COMMUNITY DEVELOPMENT  
DEPARTMENT REPORT

HEARING DATE: 11/06/2024  
TO: Mayor and City Council  
FROM: Bill Parsons, Current Planning Supervisor 208-884-5533  
[bparsons@meridiancity.org](mailto:bparsons@meridiancity.org)  
APPLICANT: Jorre Delgado, JD Planning & Consulting  
SUBJECT: H-2023-0070  
Rolling Hill - AZ, CUP  
LOCATION: 1560 Rolling Hill Drive (Parcel # R7555000032), 1520 Rolling Hill Drive (Parcel #R7555000041), 1480 Rolling Hill Drive (Parcel #R7555000050), 4270 Rolling Hill Drive (Parcel #R7555000015) and Parcel #R7555000025 in the SW 1/4 of the SE 1/4 of Section 16, T.3N., R.1E.

Annexation of 6.90 acres of land from the R-1 zone in Ada County to the C-C (Community Business District district) zone to develop two (2) vertically integrated residential structures featuring 90 dwelling units and 20,134 square feet of commercial space; conditional use permit to develop one (1) multi-family building consisting of 64 dwelling units on 5.89 acres in the proposed C-C zone. **NOTE: The CUP is only required the multi-family portion of this development. Vertically integrated residential projects are listed as principally permitted uses in the C-C zone.**

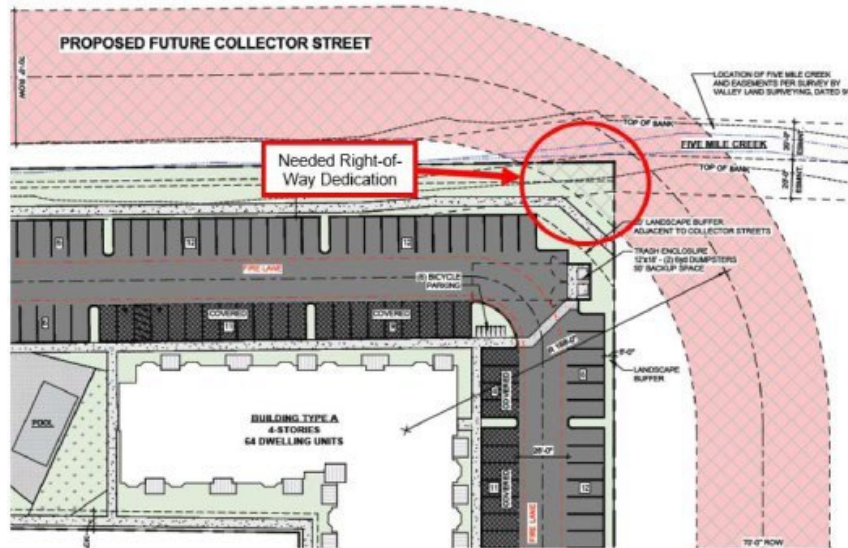
One full-access driveway is proposed via the future collector Street (Movado Way). According to ACHD's Staff Report, the Applicant should dedicate right-of way abutting the site's northeast property line to accommodate the future construction of a planned collector roadway (see figure below).

Given that both the subject property and the adjacent out-parcel at the center of this development are designated MU-R (Mixed Use-Regional) on the Future Land Use Map (FLUM), and there is no existing local street access, the Applicant, at the request of Staff, has proposed a cross-access/ingress-egress easement and driveways, including a pedestrian walkway, to facilitate future interconnectivity with this property in accordance with UDC 11-3A-3A.2. ACHD and Staff both request that the Applicant coordinate with the owner of the out-parcel surrounded by this site to close the existing driveways on Overland and provide access to the neighboring parcel internally through the site. If the driveways cannot be wholly closed, the Applicant should close the portions of the shared-access driveways that abut the site on Overland Road with an 8-foot wide planters' strip and a 10-foot wide multi-use pathway.

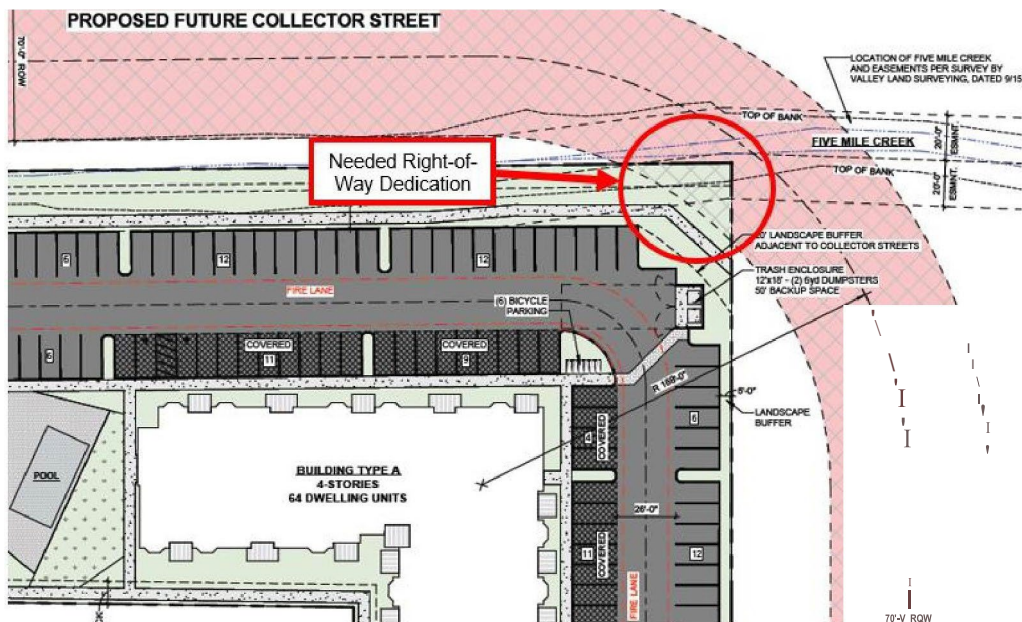
- b. Applicant Proposal:** The applicant is not proposing any improvements to View Circle abutting the site.
- c. Staff Comments/Recommendations:** The applicant's proposal does not meet District policy and should not be approved, as proposed. The applicant should be required to construct View Circle as ½ of a 36-foot wide collector roadway with curb, gutter, and a minimum of 7-foot attached sidewalk or 5-foot wide detached sidewalk with an 8-foot wide planter strip from Rolling Hill Drive to the existing terminus of View Circle 350-feet east of Rolling Hill Drive.

The applicant should be required to dedicate right-of-way to extend 2-feet behind back of sidewalk.

G. Qualified Open Space Exhibit (date: 5/23/2024)

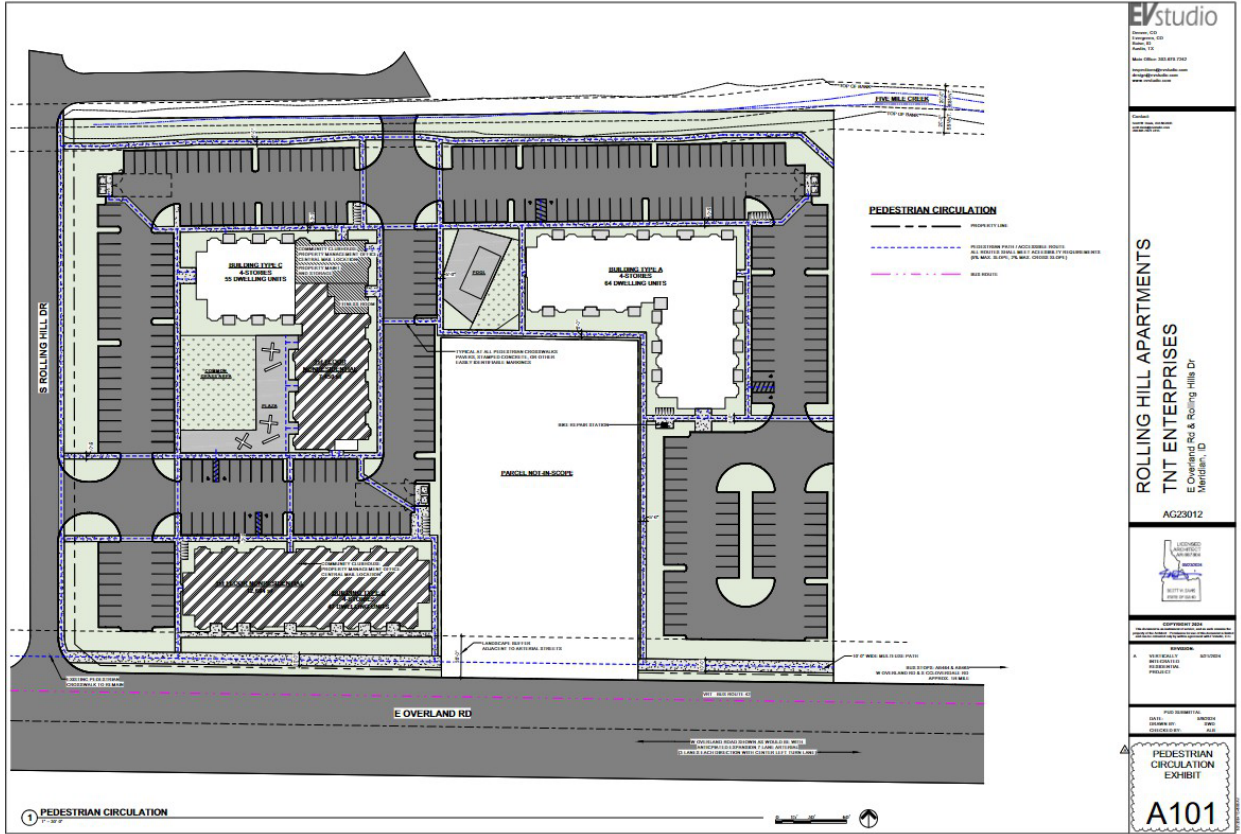
***The submitted plans feature only one common grassy open space area of 5,000 square feet in size.***
